City of Del Mar Staff Report

DATE: January 4, 2016

SUBJECT: Adoption of a Resolution Approving a *Design Review Permit* (DRB15-017), *Coastal Development Permit* (CDP15-010), *Land Conservation Permit* (LC15-0108), and *Tree Removal Permit* (TRP15-014) for the City Hall/Town Hall/Plaza Project located at 1050 Camino del Mar in the Public Facilities Zone

1. Town Hall Terrace/Expansion Area B:

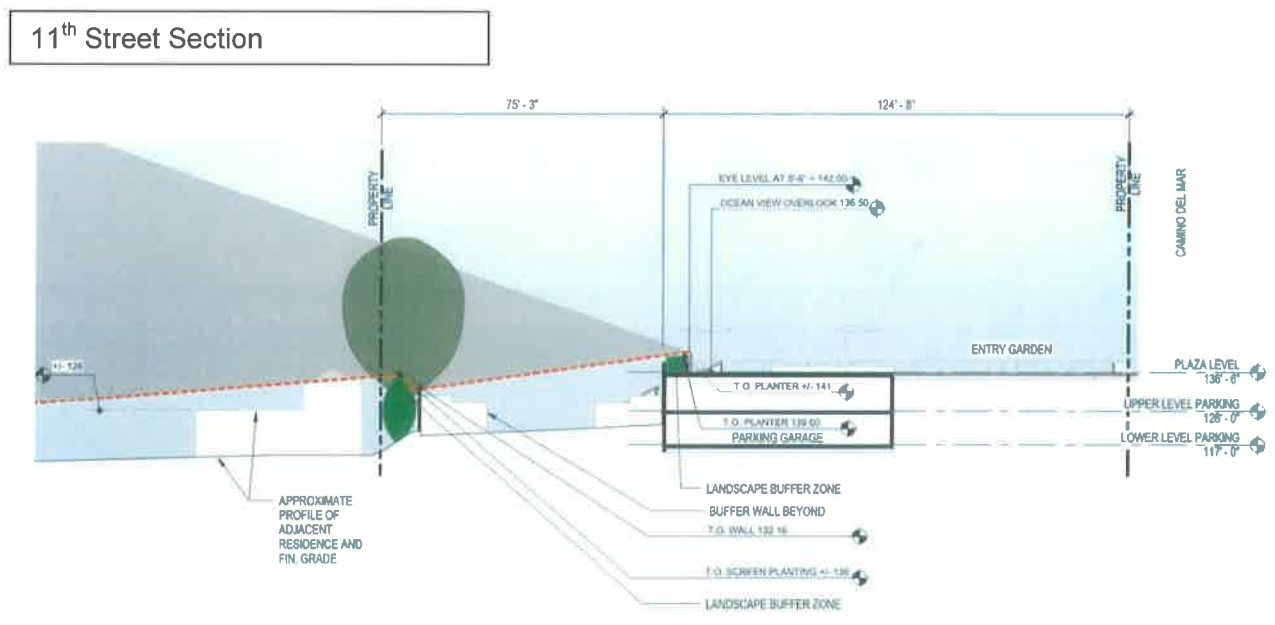
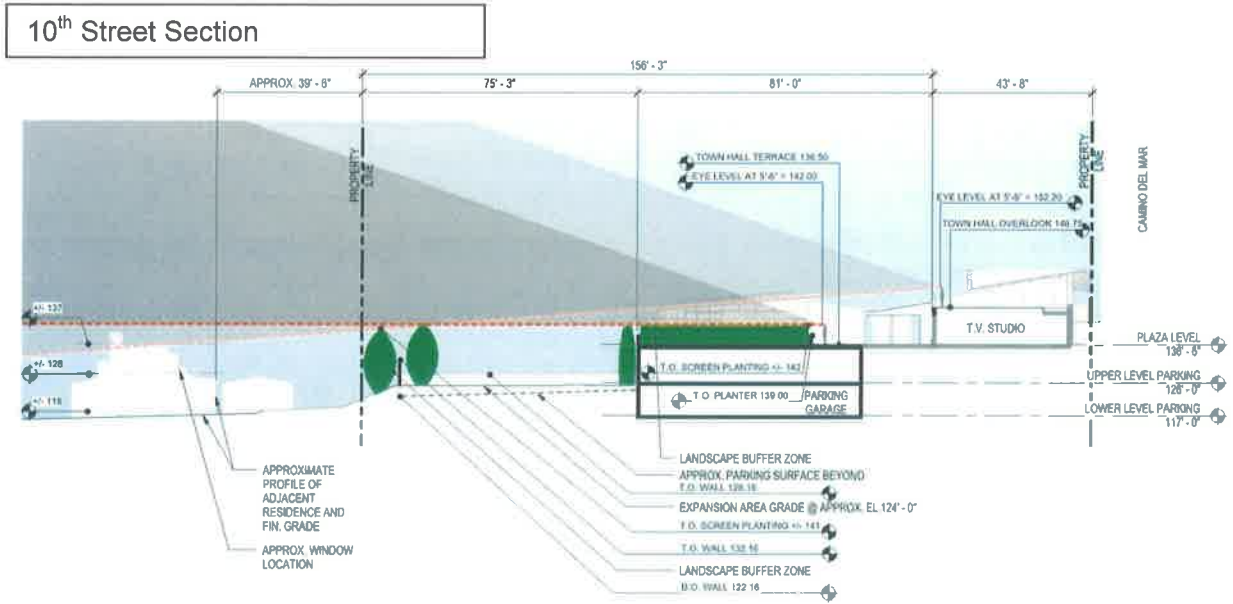
1. Privacy, noise and glare issues from Town Hall Terrace (Expansion Area B)
2. Privacy, noise and glare issues to adjacent property owners along the western, southwestern and northwestern sides
3. Traffic circulation and distribution
4. Potential reduction in parking

Town Hall Terrace was originally proposed at 2,500 square feet for public access and outdoor gathering. The option shows a reduced plaza, approximately 300 square feet in the northeast corner and maintains the egress route. All other areas would be landscaped or unused, with some screening shrubs (approx. elevation 142) that will block the visual access to surrounding residences. The reduced Terrace would be gated and not open to the public after the close of business, limiting any potential noise or glare.

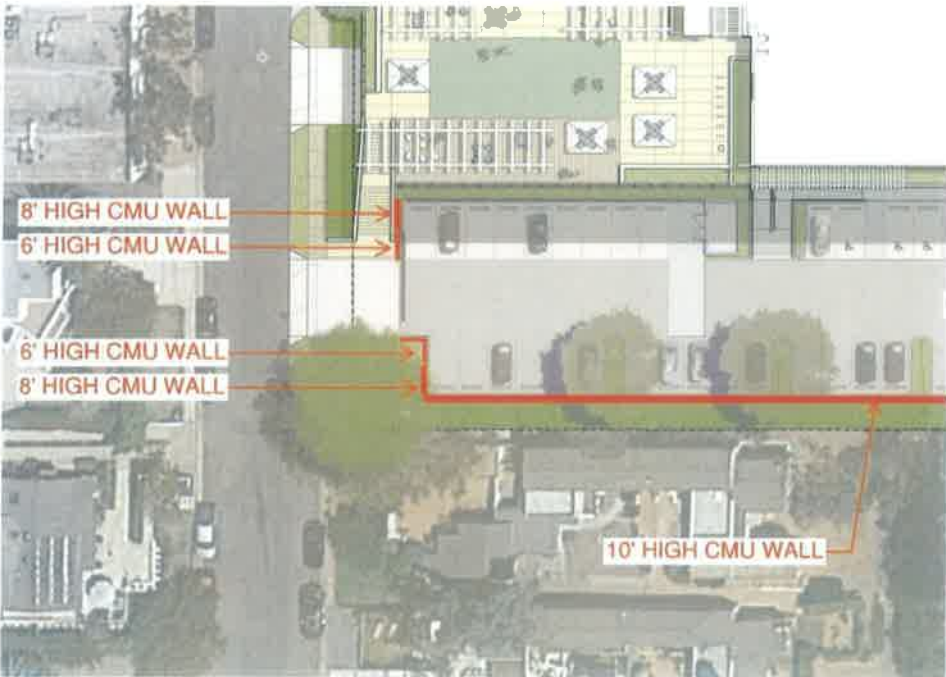
Option for addition of planting up to elevation 142, a 10 foot screen wall on the western setback line (10 feet from property line) and 6 foot screen walls with planting to screen the north and south ends of the parking lot per the diagrams below.

3. Traffic circulation and distribution

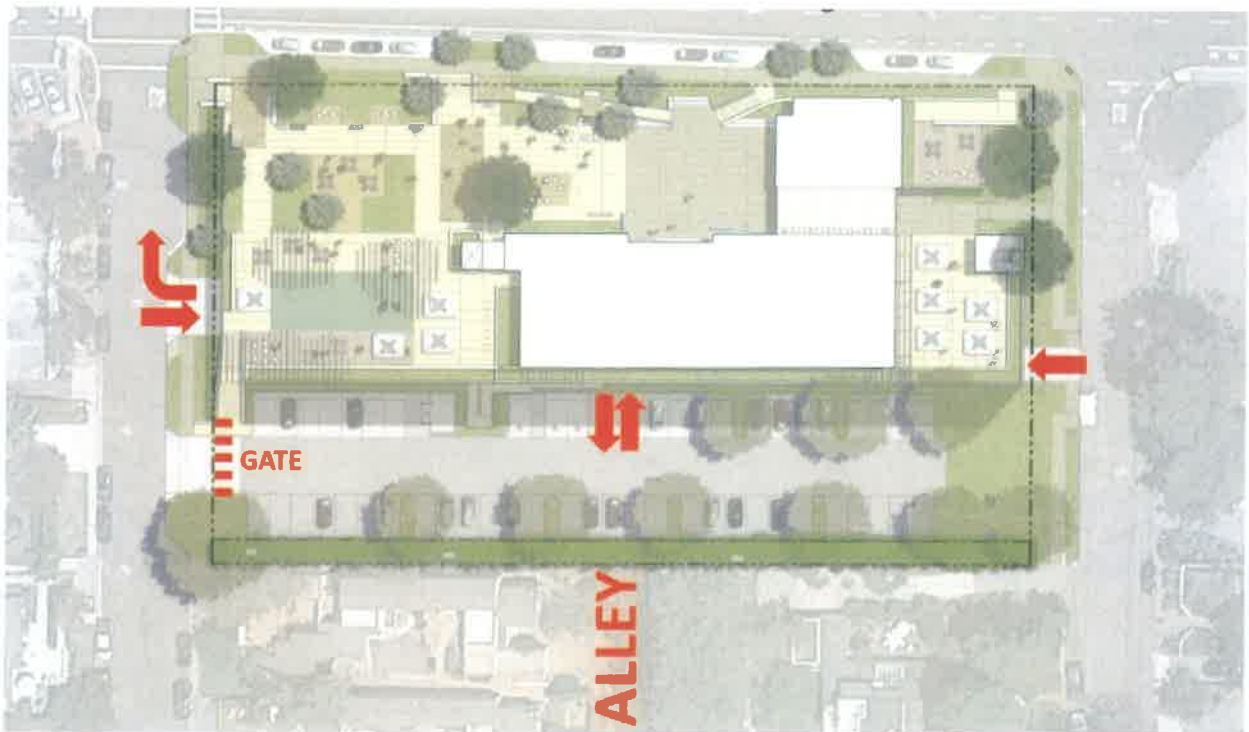
Option to gate the surface parking lot at 11th Street for regular use, and limit that 11th Street gated access to emergency and high profile vehicles or special events (Farmer's Market, etc.). In addition, provide a connection between the parking garage and the surface parking lot. This will direct access away from the adjacent residential and direct egress closer to Camino del Mar. The location of the connection (driveway) would be in line with the alley to the west rather than opposite residential. There is no connection to the alley due to grade differential. This option promotes visitors to park in the garage first before using the surface lot.
